## NOTICE TO APPLICANTS ADDENDUM NO. THREE (3)

### Highland View (Gulf County) Boat Ramp Improvements DEP Bid NO. BDC03-19/20

SHEET NO. **C100**

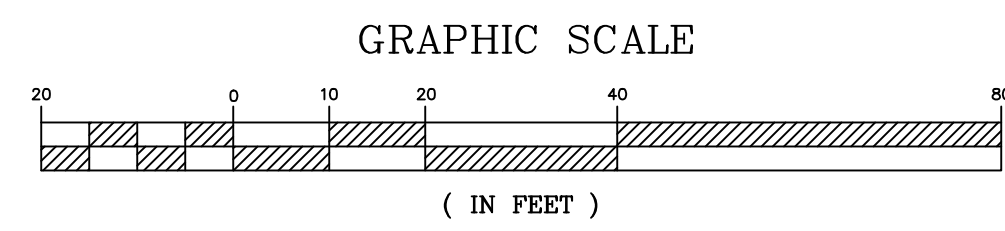
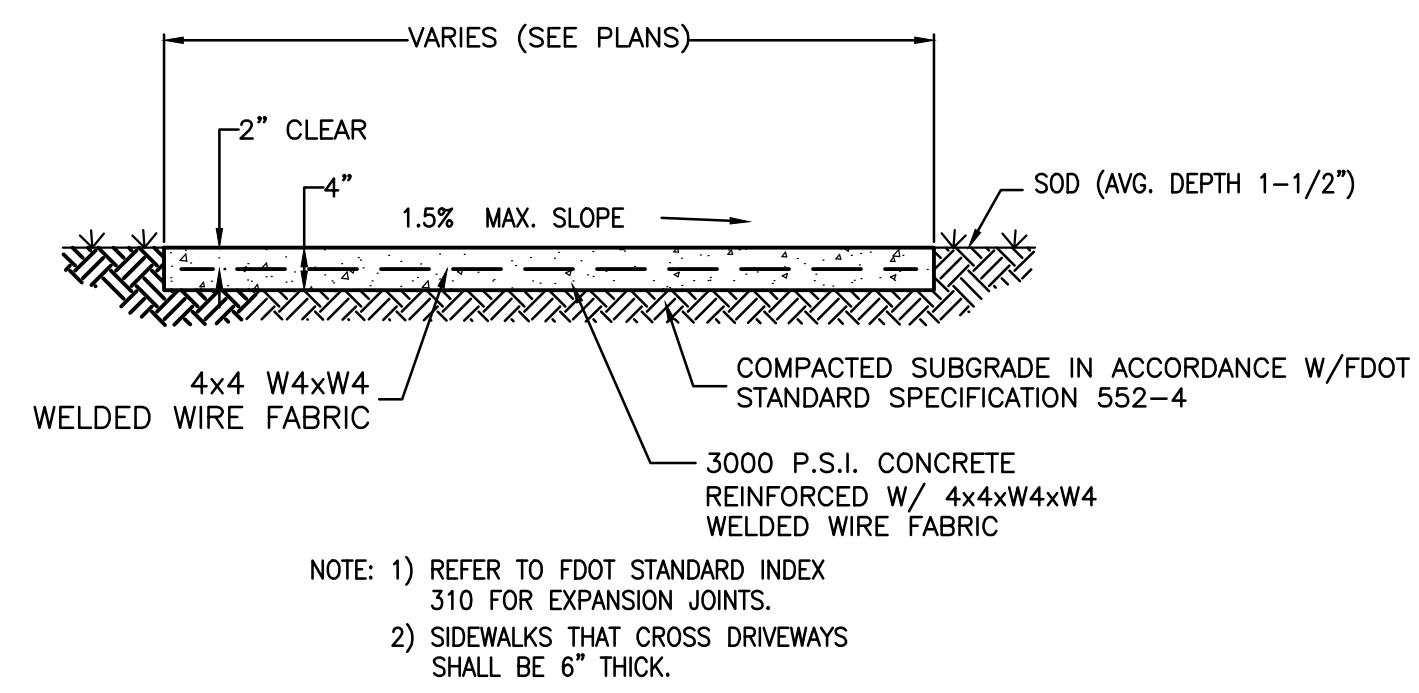
- 1. Question:** Sheet C100 shows the existing asphalt to be demolished and removed but on Sheet D100 the typical pavement resurfacing section shows a 2" thick resurfacing over the top of existing asphalt. Please clarify what is required for the asphalt.

**Answer:** Please see revised Sheet. Only section of asphalt is to be removed that is connecting to the boat Ramp. See revised Sheet C100 and D100 A new detail has been provided for the section connecting to the boat ramp. Contractor shall mill and resurface portions of the roadway damaged during construction.
